Civil Action No. H-79-704 (JAC)

CERTIFICATION OF JOHN H. GUSWA

EVALUATION OF THE PAST PERFORMANCE
OF THE ON-SITE RECOVERY SYSTEM
AT THE
SOLVENTS RECOVERY SERVICE OF NEW ENGLAND, INC. FACILITY
IN SOUTHTON, CONNECTICUT

Figure 1. Target zone of influence calculated by YWC
 (Ref: Hoagland Declaration Exhibit 10, Drawing 3)

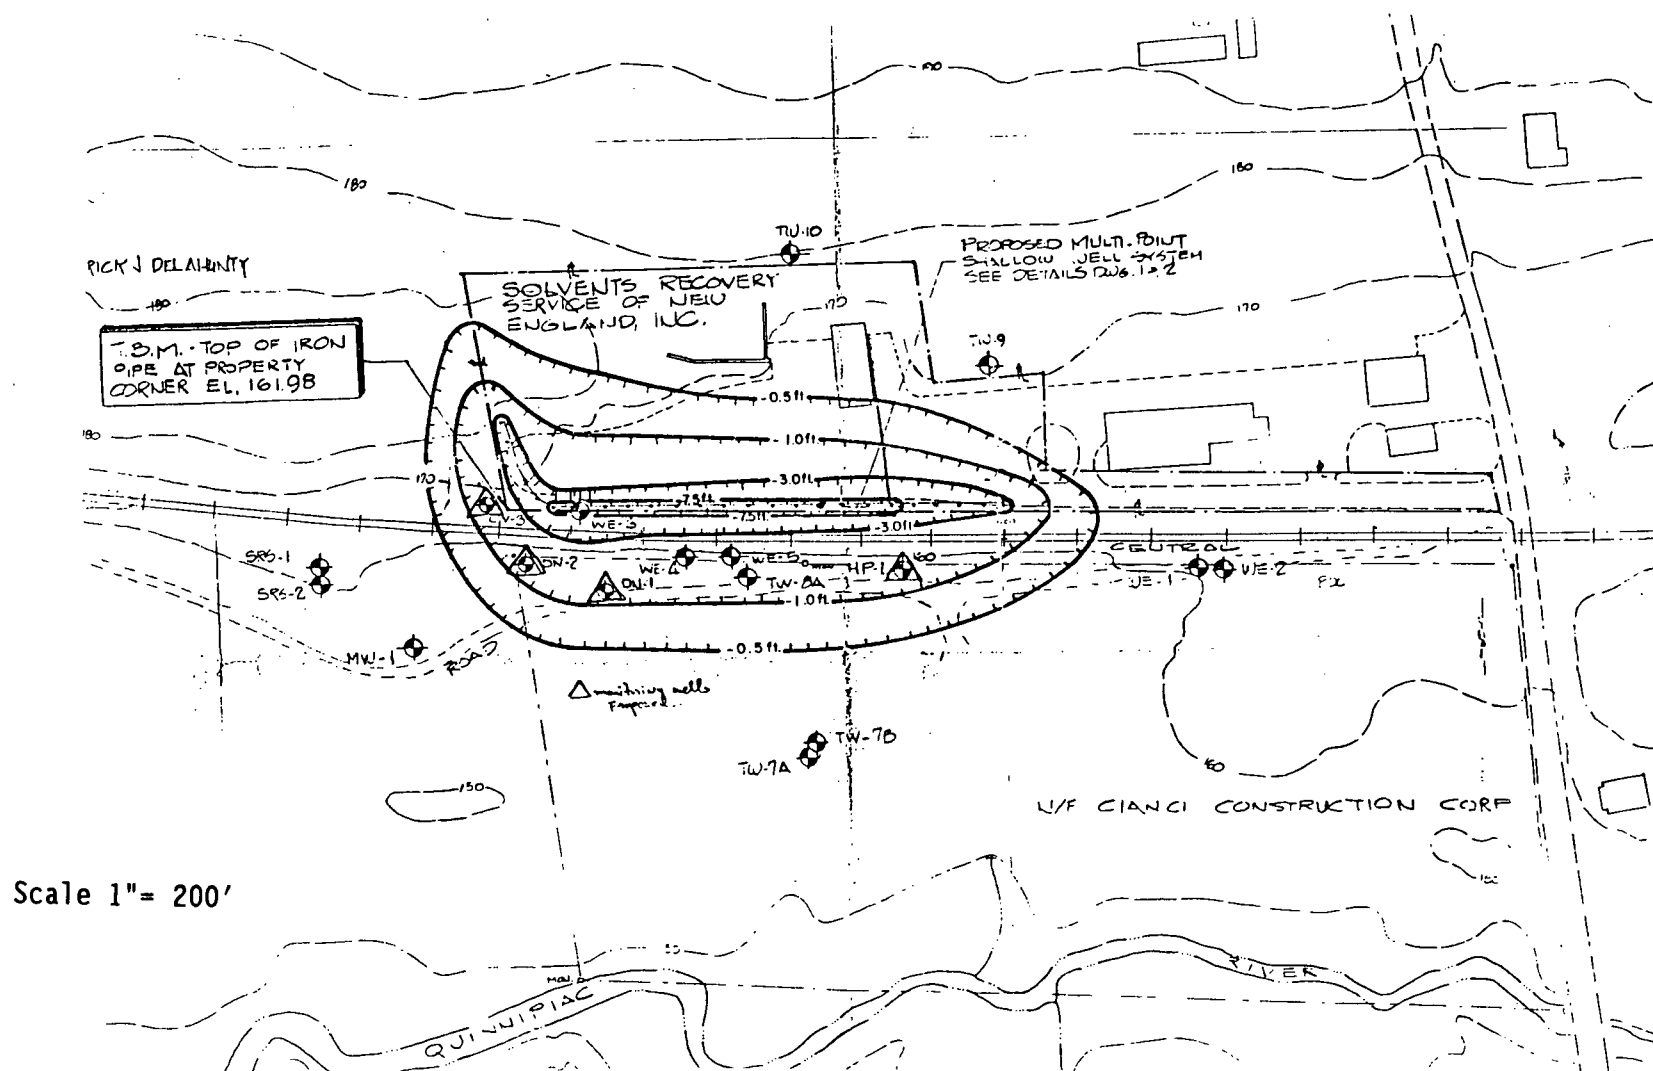
Figures 1 through 3 have been prepared to illustrate how the calculated zone of influence and the natural water level slope are combined to determine the zone of capture of the pumping wells. Figure 1 is a copy of

the zone of influence contained in the YWC report (Hoagland Declaration Exhibit 10, Drawing 3). Figure 2 is a copy of the water table contour map for March 11, 1980 (Wehran, 1982, Sheet 3). March 11, 1980 is one of four dates for which such maps have been prepared by Wehran (1982). Figure 2 shows the water table elevations under non-pumping conditions. The procedure for determining the expected water levels under pumping conditions is to superimpose the calculated drawdown onto the non-pumping water level map. The calculated drawdown is arithmetically combined with the non-pumping water level and an expected pumping water level is calculated. Figure 3 illustrates the result of combining Figures 1 and 2. The resultant map is used to interpret the region within which flow is toward the pumping wells. The zone of capture as indicated on Figure 3 is the region within which flow is predicted to be toward the pumping wells. The zone of capture as shown on Figure 3 does not extend as far downgradient of the SRSNE site as does the zone of influence shown on Figure 1.

Figure 3. Estimated zone of capture of on-site system based on the YWC calculated zone of influence and March 11, 1980 water elevations

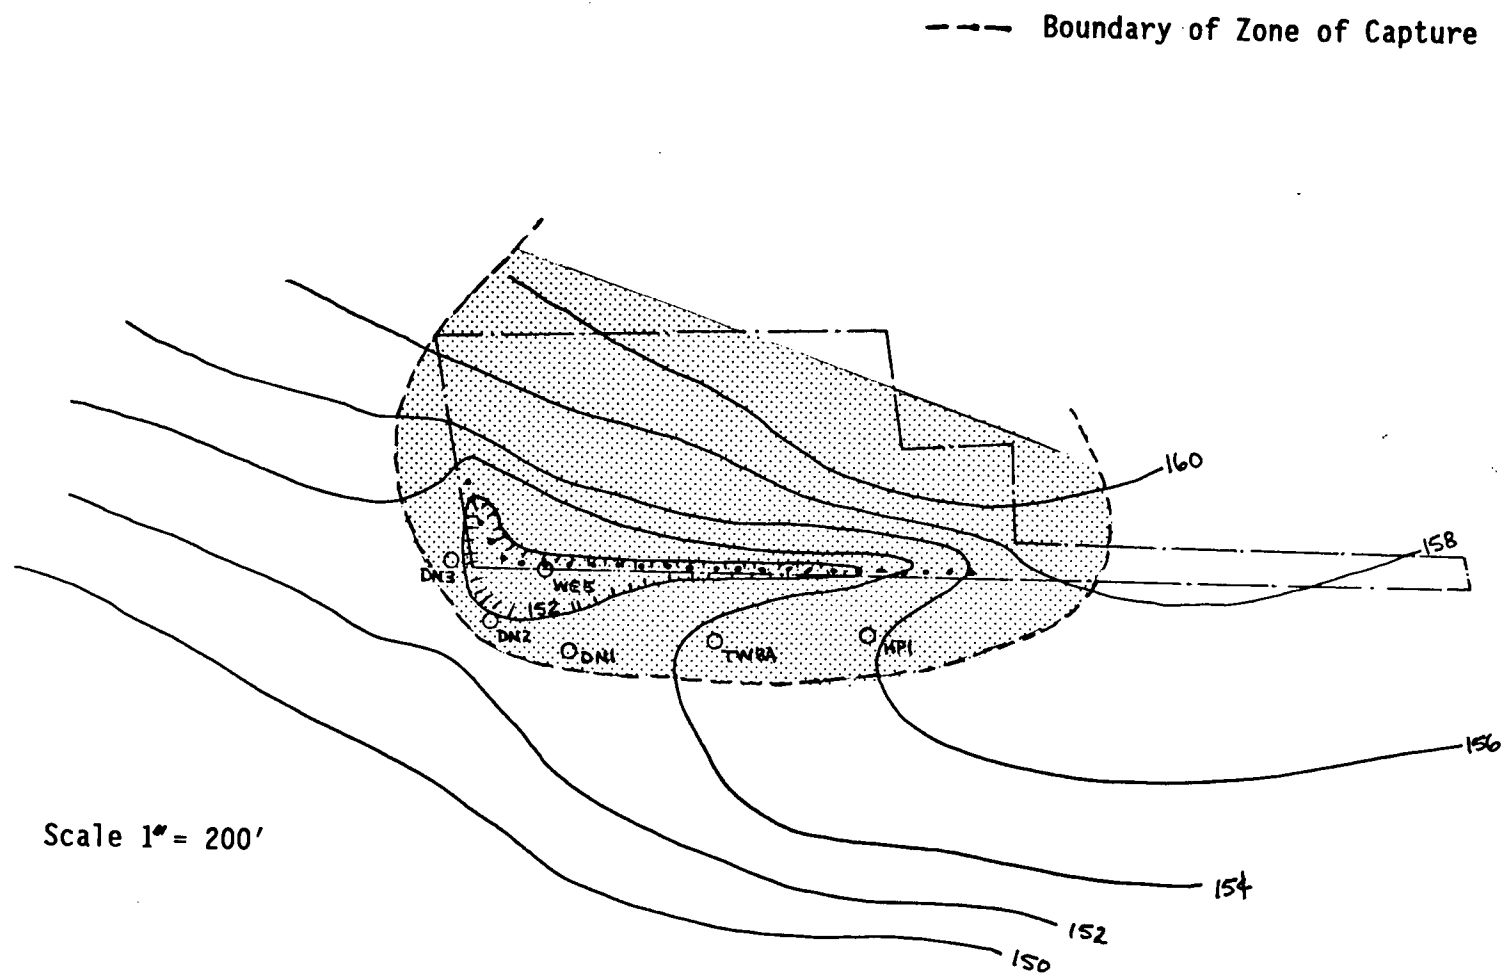
It is unusual to encounter conditions where the water table does not slope. It should be expected, therefore, that the zone of capture and the zone of influence would not be the same. In other words, the natural water level conditions limit the extent of the zone of capture of the pumping wells and make it impossible for the zone of capture to coincide with the zone of influence.

Figure 30. Water Level Elevation USGS Well WB 198

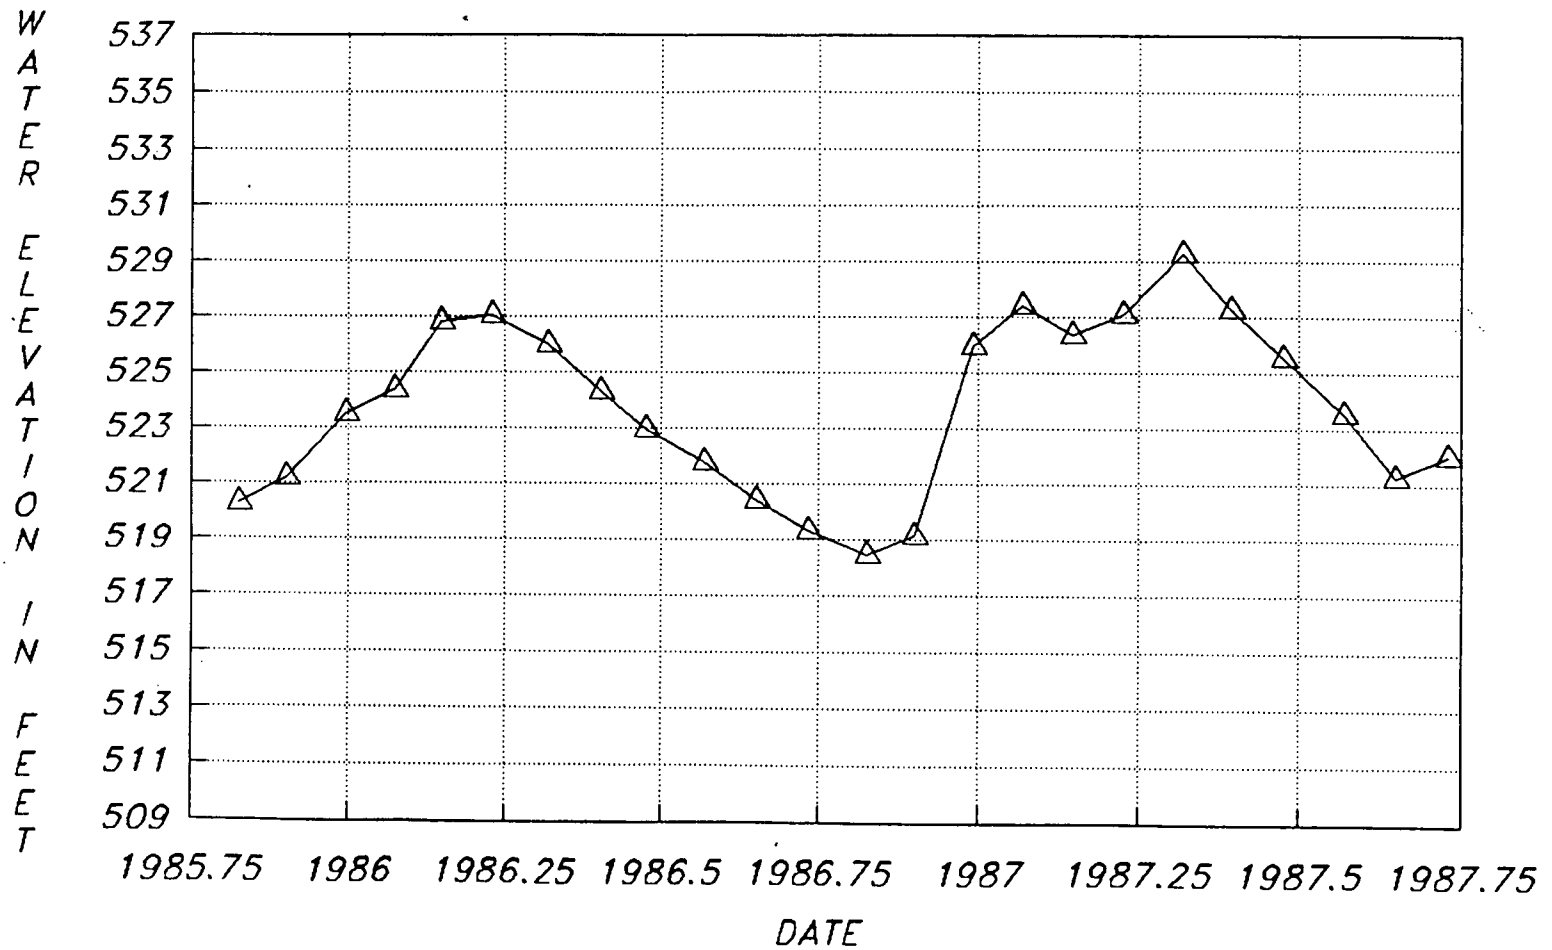
measurements. Water level data for this well were considered to be an estimate of the seasonal range in water levels which might be expected to occur at the SRSNE site under non-pumping conditions. Figure 30 is a graph of the water level measurements reported for the period October 1985 through September 1987. The data indicate that the January 1986 water level measurement is about the middle of the range of water level fluctuation for the reporting period. This suggests that the on-site system baseline water level measurements probably represent an average water level condition. The graph also indicates that the 1987 water levels were slightly higher than the 1986 water levels.

Water level data for the on-site recovery wells reflect both the effects of pumping and seasonal water level changes, and it is not possible to directly determine how much of the change is due to pumping and how much is due to seasonal water level variations. Water level data from USGS monitoring well WB 198 suggest that natural water level fluctuations may be about four feet above and below the baseline elevation. Regardless of the inability to differentiate what portion of the observed water level changes in the recovery wells is due to pumping, it is clear that water levels in many of the wells were much lower than were previously expected (Hoagland Declaration Exhibit 10, Drawing 2). Drawing 2 indicates that the expected water level in the pumping wells would range between about 10 to 20 feet above the bottom of the recovery well. Twenty three of the 25 recovery wells had one or more measurements which indicated that water levels were at or below the well bottom. For some of the wells, such as 1, 2, 4, 14, 15, 19, and 23, there were several measurements which indicated that water levels were at or below the well bottom.
